### WELLINGTON CITY COUNCIL REPORT OF THE HEARING COMMITTEE

PROPOSED DISTRICT PLAN CHANGE 48: CENTRAL AREA REVIEW

**DATE OF HEARING:**

16<sup>TH</sup> – 30<sup>TH</sup> MAY 2007

Diagram of site-specific development concept for 187 Featherston Street. First setback occurs at ~35m, second setback at ~50m, and the max threshold set at 65m (all heights measured above ground level).

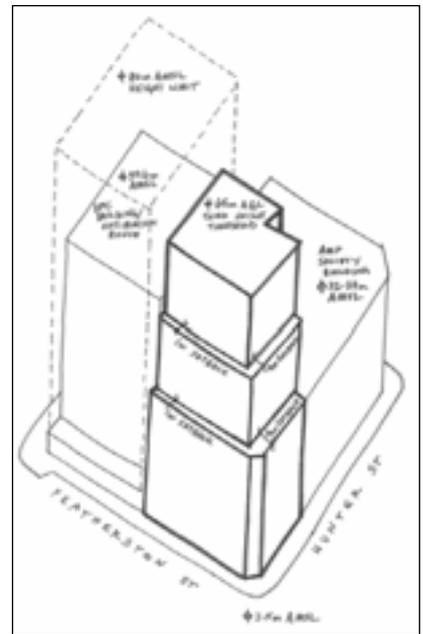
Submitter 16 (AMP NZ Property Commercial Ltd) originally submitted that their property at 187 Featherston Street (AMP Chambers) should be removed from the BNZ/Head Office Heritage Area, or alternatively that the permitted height for the site should be set at 80 metres. At the hearing the submitter presented a site specific development proposal for the AMP Chambers site, that the submitter considered was an appropriate response to the setting. The design (see image to right) extended up to a maximum possible height of 65 metres (above ground level) and made use of setbacks to ensure that the resulting building would respect the scale of the heritage area, provide a transition from the taller buildings to the north to the shorter heritage buildings to the south, and acknowledge the scale of the adjoining AMP Society building. The submitter provided the Hearing Committee with a three dimensional scale model of the proposed building in its setting, showing the surrounding buildings. The submitter requested that the Committee put in place a site specific rule to clarify that the development proposal was an appropriate development for the AMP Chambers site. Having visited the site, and considered the nature and scale of the surrounding buildings and spaces, the Hearing Committee agreed with the submitter that the proposed development scenario would be appropriate for the site. However the site visit also persuaded the Committee that there was potential for additional height on other sites within the BNZ/Head Office Heritage Area, given the area location in the heart of the 'high city' and the height of buildings on the perimeter of the heritage area. The height provisions for the area have therefore been amended to provide scope to consider scenarios such as that presented by AMP. Accordingly the Committee did not consider that a specific rule was required to codify the AMP proposal, and noted that the submitter may choose to investigate alternative options in the future. The Committee did however consider that it was worth including the development scenario in the design guide for the BNZ/Head Office Heritage Area, along with a note in rule 13.6.3.1.6 that in terms of building bulk it represented an appropriate design response for the site.

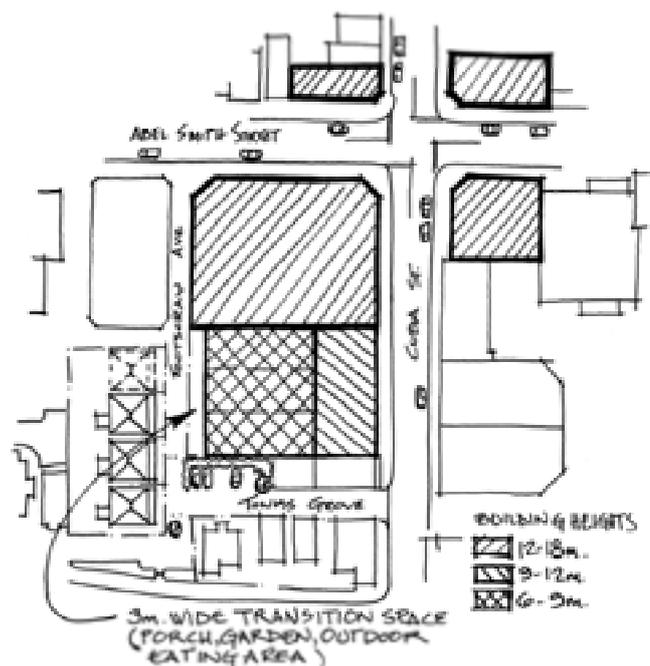
The Hearing Committee agreed with submitters that the sites between Abel Smith Street and Tonks Grove did have a different character to the properties south of Tonks Grove and west of Footscray Ave. The Committee installed a separate height regime for this portion of the heritage area to acknowledge this.

In terms of the heights that applied in this area the Hearing Committee identified a number of key issues that needed to be addressed. The Committee felt that additional height at the Cuba Street/Abel Smith Street intersection would help to anchor and enclose what is currently a fairly poor quality public space.

incorporated each of these issues. The scenario (see image to right) is not a specific design solution, but is intended to alert architects and applicants to the matters that need to be addressed in any future application.

*Image: Footscray Avenue cottages*

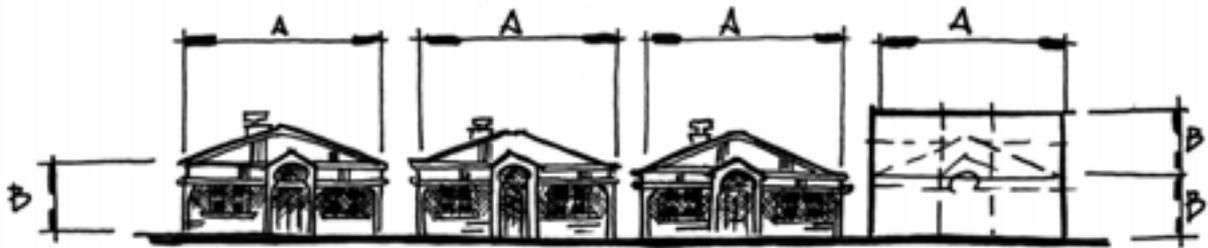
Submitter 26 (Dr Marko Klatkovic) owns the property at number 2 Footscray Ave (containing a cottage) as well as the larger commercial buildings to the north. The cottage is a listed heritage item that was damaged by fire in late 2006. The submitter opposed the inclusion of the cottage in the heritage area, and sought reinstatement of the previous 27 metre height limit. Having visited the site the Committee did not consider that the cottage should be removed from the Cuba Street Heritage Area (see section 3.78 for further details). The Committee considered that the Footscray Cottages were an important reminder of the city's past, and that the site at No. 2 Footscray Ave was important to the context of the remaining cottages, even if it was not possible to physically retain the fire damaged cottage. The Hearing Committee were strongly of the opinion that any future redevelopment of the site at No. 2 Footscray should echo the previous structure, and retain very strong links to the design and form of the remaining cottages (see image below).

The Committee directed that additional design guidance be included in the Cuba Street Heritage Area Design Guide to help clarify this matter.

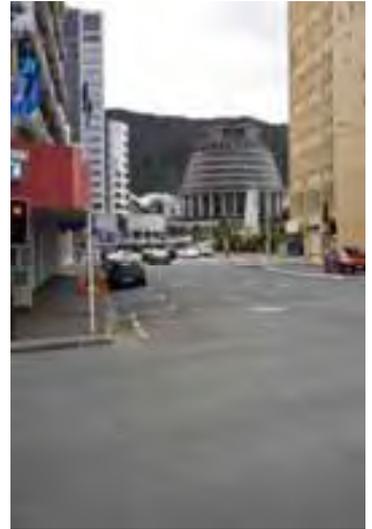
The remaining land stretching toward the Carillon is zoned Central Area, but is limited to an 18m permitted height. Again, this would not detract from the view of towards the Memorial.

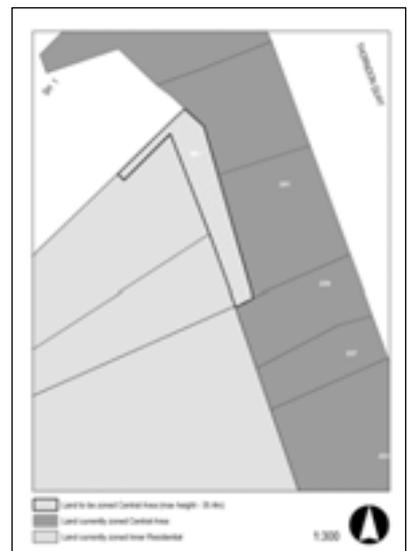
- The submitter opposes the zoning of the former Hotel Cecil site which excludes the part area of bus parking that is under dispute with the Wellington City Council (with that part being left as 'road'). The relief sought is the incorporation of the whole of the former Hotel Cecil site within the Central Area zone. As an alternative relief, the provision of adequate financial compensation for the "taking" of the land for road purposes, with the financial compensation being based on an underlying zoning of Central Area (submission 53).

- Amend DP Map 18 as follows, to correct an apparent zone anomaly relating to properties on Thorndon Quay:
  - a) Display subdivided Lots 1-4 DP 348486 on DP Map 18.
